ENGINE - OIL - TO REMOVE THE INLET DUCT RIB OF THE ACOC INLET DUCT ASSEMBLY - CATEGORY
CODE 6 - MOD.ENG-79-0048

The ribs of ACOC Inlet Duct are removed to reduce high stress on the rib.

Before and After the Alteration of the ACOC Inlet Duct Assembly
Fig.1

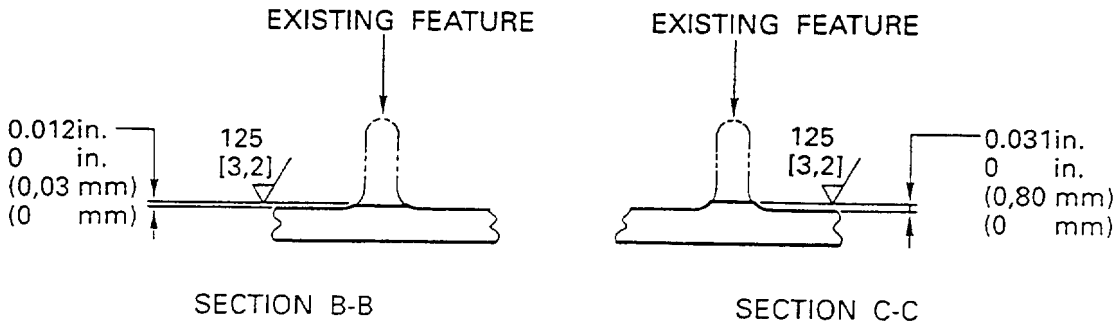
- (1) Condition
High stress on lower/rear rib of ACOC Inlet Duct.
- (2) Background
This condition was observed during the flight test program.
- (3) Objective
To reduce stress area on the duct.
- (4) Substantiation
The configuration change shown in this Service Bulletin has been substantiated by analysis.
- (5) Effect of Bulletin on Workshop Procedures:

- (1) Affected part numbers of the ACOC Inlet Duct are follows:
 - (a) 5T0116 (79-21-42, 01-400)
 - (b) 5T0101 (79-21-42, 01-400)
- (2) Remove the rib of the ACOC Inlet Duct by grinder and files as Figures 1 and 2.
- (3) Reidentify the part number of the ACOC Inlet Duct from 5T0116 to 5T0134 adjacent to the existing part number by vibration peening. Delete the existing part number with a single solid line, Refer to 1.K.(3).
- (4) Reidentify the part number of the ACOC Inlet Duct from 5T0101 to 5T0138 adjacent to the existing part number by vibration peening by hand. Delete the existing part number with a single solid line, Refer to 1.K.(3).
- (5) Remove the burrs at new and deleted marking positions by CoMat 05-016 or 05-017 Garnet Paper.
- (6) To apply the CoMat 01-275 chromate conversion coating to ground face of the rib and non anodic portion by the brush, Refer to 1.K.(4).
